## PROPOSAL 6-3 (2009)

### SCOPE: Part 1 of the 2009 Provisions

Figure 1. Bracing connection detail that accommodates local rotation demand.

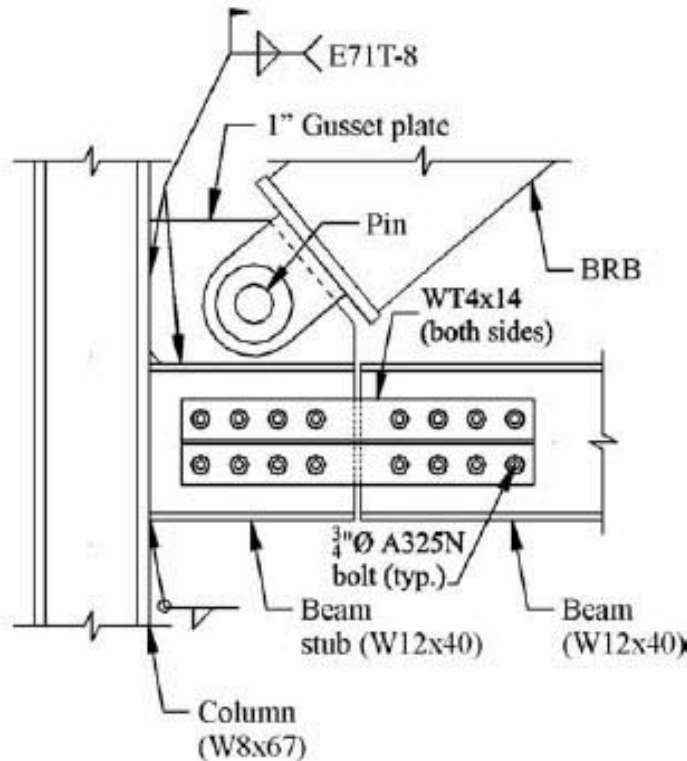
ASCE 7-05 included two different systems for both Eccentrically Braced Frames (EBF) and Buckling Restrained Braced Frames (BRBF). The primary distinction between these two systems was whether or not there were moment resisting beam-column connections within the braced bays. Recent testing at UC Berkeley (Uriz and Mahin, 2004) has indicated that designs that do not properly account for the stiffness and distribution of forces in braced frame connections may be subject to undesirable performance. This proposal consolidates the EBF and BRBF building frame systems into a single designation, with proper consideration of the beam-column connection demands. The proposal allows the engineer to either provide a fully restrained moment connection meeting the requirements for Ordinary Moment Connections in AISC 341-05, thereby directly providing a load path to resist the connection force and deformation demands, or to provide a connection with the ability to accommodate the potential rotation demands. An example of this would be a configuration tested at Lehigh University (Fahnestock, et. al. 2006), shown in Figure 1 that effectively formed a pinned condition in the beam just beyond the beam-column-brace connection.
